**NEDO-33243-A Revision 2, "ESBWR Marathon Control
Rod Mechanical Design Report"**

NEDO-33244-A Revision 2

ESBWR MARATHON CONTROL ROD

MECHANICAL DESIGN REPORT

Figure 3-1. Control Rod Assembly Welds and Cross-Sections Analyzed for SCRAM

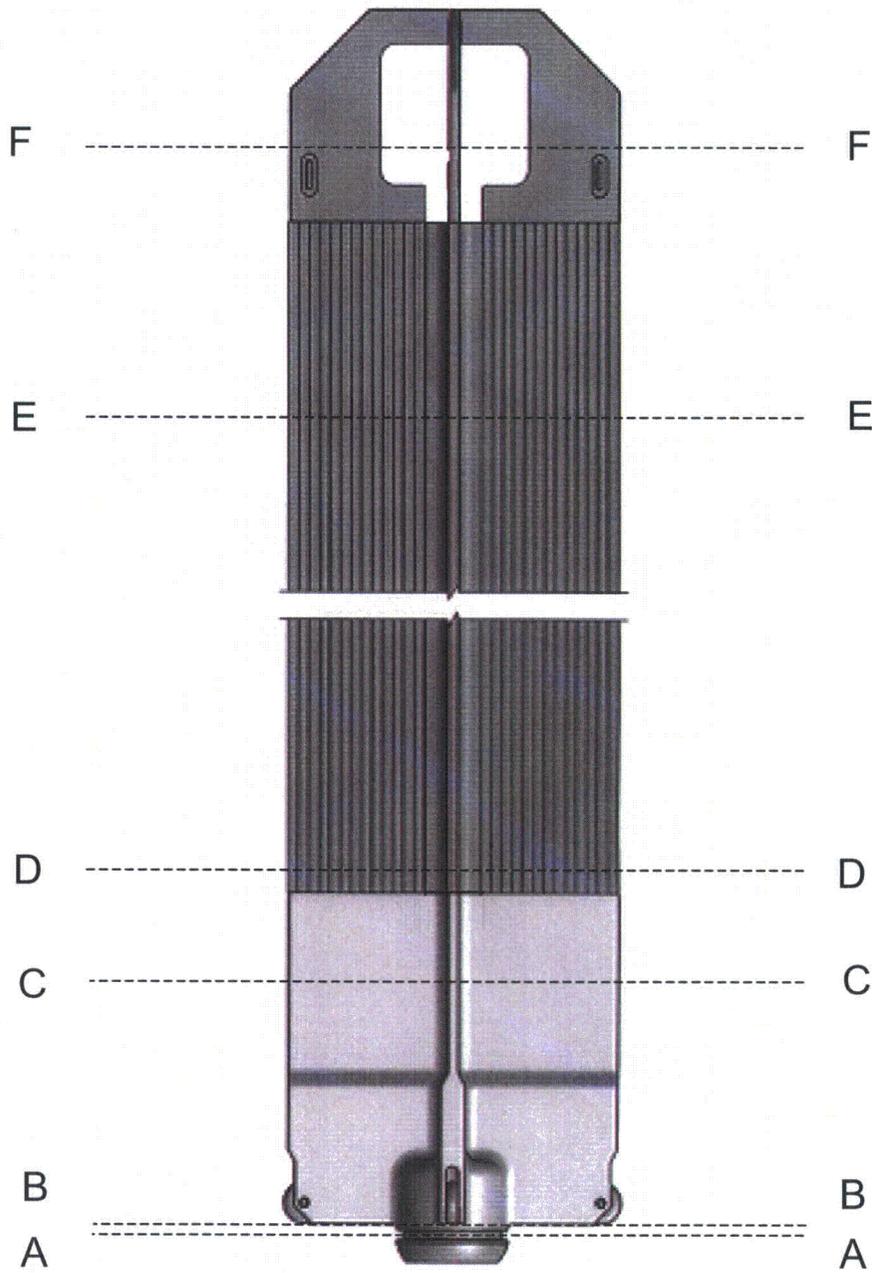
Conservative structural analyses of the CRB were performed assuming 100-percent failed control rod drive buffer. Structural stresses were determined from scram loads, using weld quality factors and worst-case geometry (Figure 3-1 and Table 3-4 of Reference 1). Table 3-5 of Reference 1 indicates that sufficient margin exists against failure for all cross-sections and welds.
